Review 2

Mahalaxmi Bayonne Urban Renewal, LLC
General Development Plan Amendment

Application P-23-017
Harbor Station South Redevelopment Area (HS-2 District)
One Flagship Street
Block 751, Lots 1.11, 1.14, and 1.15

February 10, 2025

Figure 2. GDP Application Diagram

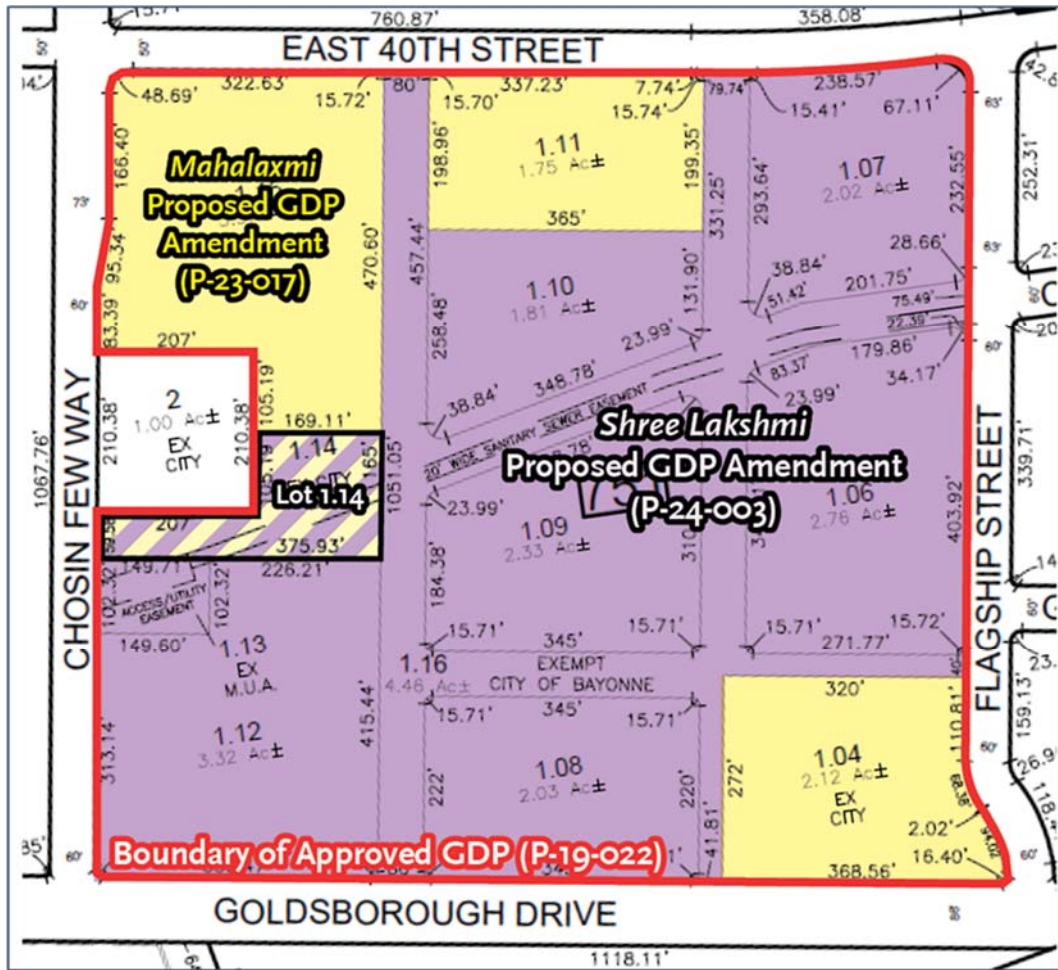
- 1.3. Concurrent GDP Application.** A separate GDP amendment application has been submitted by Shree Lakshmi Bayonne Urban Renewal, LLC (P-24-003), for Lots 1.04 and 1.06-1.16. The area of the GDP amendment requested by Shree Lakshmi is 19.65 acres and shaded purple in Figure 2. The Shree Lakshmi GDP amendment application proposes 17 buildings to be constructed in 14 phases, consisting of 11,900 dwelling units, 499,600 square feet of ground floor retail space, 500 hotel rooms, 13,054 off-street parking spaces, 135 on-street parking spaces, and 86,660 square feet of open space and/or building amenity space. The application includes the proposed street network (Lot 1.16) and open space (Lots 1.13 and 1.14). Elements of the Shree Lakshmi application are included within this report to better understand the full extent of changes and impacts of amendments to the approved GDP.

- 1.4.2. Lot 1.14 is Double Counted.** Both applications for GDP amendment include Lot 1.14 in their open space calculations. The lot is owned by the City of Bayonne. **Lot 1.14 should be removed from this application unless it is removed from the Shree Lakshmi GDP application (P-24-003).**

Lot 1.04 as indicated in the proposed amended GDP. The light gray area of the building has been developed.

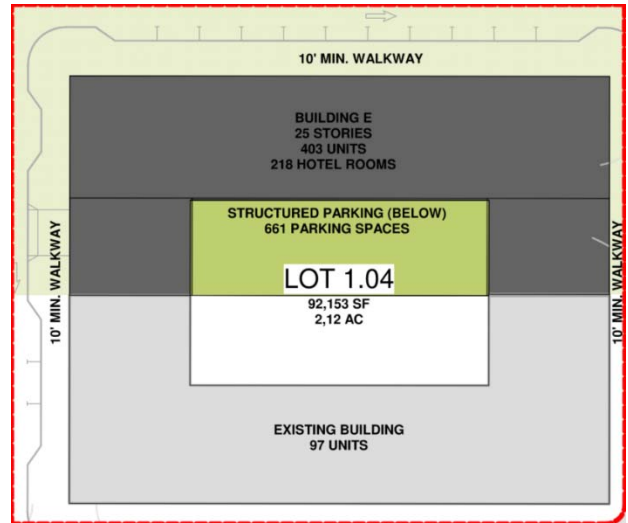
3.3.1. Lot 1.04. Lot 1.04 is the only parcel within the GDP that has been developed. An existing five story building with 97 units and 97 parking spaces³ was developed pursuant to a prior Board approval. Next to the building at its rear, “Building E” is indicated for future development, containing a 25-story building with 403 residential units and 218 hotel rooms, served by 661 parking spaces, that would be attached to the existing building to create one larger structure. Lastly, 3,120 sf. of commercial space is either proposed, existing, or would be a combination of both conditions. This is a change

from the original GDP. The original GDP included the 97-unit building, but the rear portion was originally indicated as “Building A2” and was intended to contain 12 stories with 272 residential units and 107 parking spaces. Additionally, this parcel was slated for 12,769 sf. of commercial space. **It is unclear from the GDP how the proposed amendment will affect the existing surface parking lot and the area between the existing building and proposed Building E.**

Lot 1.11 (above) and Lot 1.14 (below) as indicated in the proposed GDP.

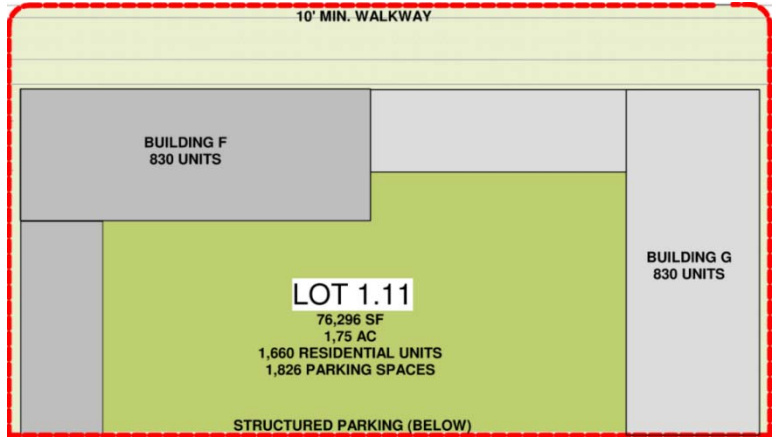
3.3.2. **Lot 1.11.** Two buildings and structured parking are proposed on Lot 1.11. It consists of Buildings F and G, both of which are 50-story towers containing 830 residential units (for a total of 1,660 residential units). A parking structure is also proposed containing 1,826 parking spaces. The “Commercial Area Summary” table located on sheet 3 of the GDP indicates that Lot 1.11 will contain 6,229 sf. of commercial space. This is a change from the original GDP. The original GDP included a 10-story building labeled “Building D3” with 207 residential units on Lot 1.11. Additionally, a 76,296 sf. parking structure was proposed.

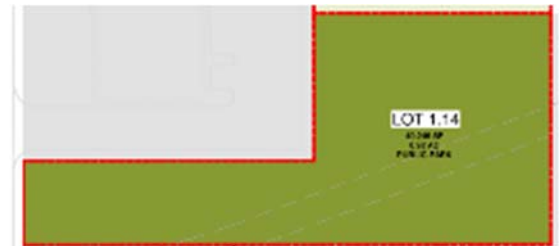
3.3.3. **Lot 1.14.** Lot 1.14 is proposed to contain a public park encompassing the entirety of the parcel totaling 0.92 acre (40,246 sf.). This appears to be in line with the original GDP which was indicated as a “Park Lot” and encompassed the same area. **This lot is included in another application as noted elsewhere in this report.**

Lot 1.15 as indicated in the proposed GDP. Building A (dark gray) received site plan approval.

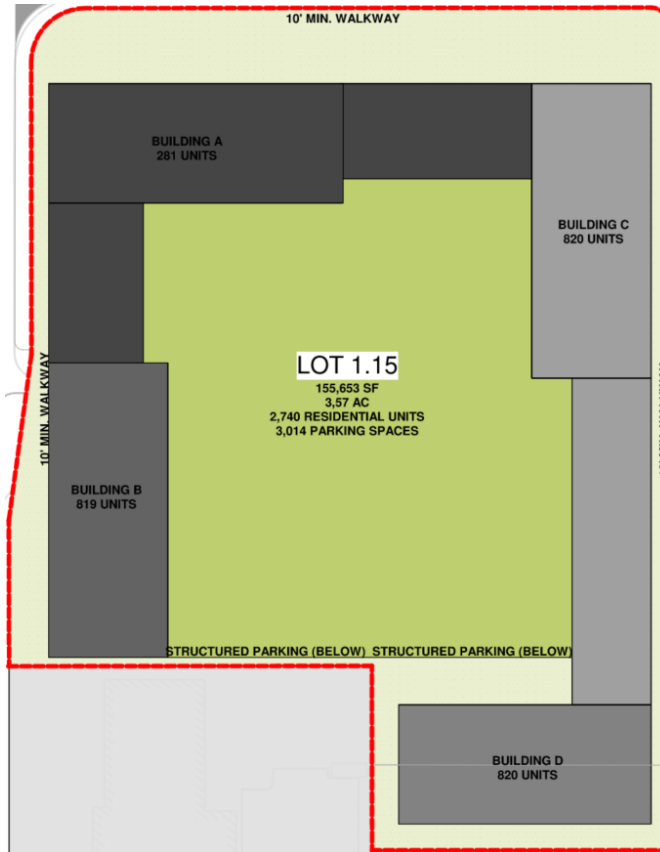
3.3.4. **Lot 1.15.** Lot 1.15 is proposed to contain four buildings, indicated as Buildings A, B, C, and D. the size of the lot is 3.57 acres. Building A was the subject of an approved site plan application in 2023. Building A is 26 stories and has 281 residential units. Building B is 50 stories and 819 units. Building C is 50 stories with 820 residential units, and Building D is 50 stories and contains 820 residential units. The total number of proposed residential units is 2,740. The GDP indicates there will be 3,014 total parking spaces in structured parking, though the configuration of the parking is unknown outside of the already approved Building A. The “Commercial Area Summary” table located on sheet 3 of the GDP plan indicates that Lot 1.15 will contain 15,383 sf. of commercial space.

This is a change from the original GDP. As detailed at the time of site plan application for Building A, the GDP previously contained a 10-story hotel with 218 rooms, two eight-story buildings with 91 residential units and 117 residential units, a six-story parking garage with 567 parking spaces, and a surface parking lot with 89 parking spaces.
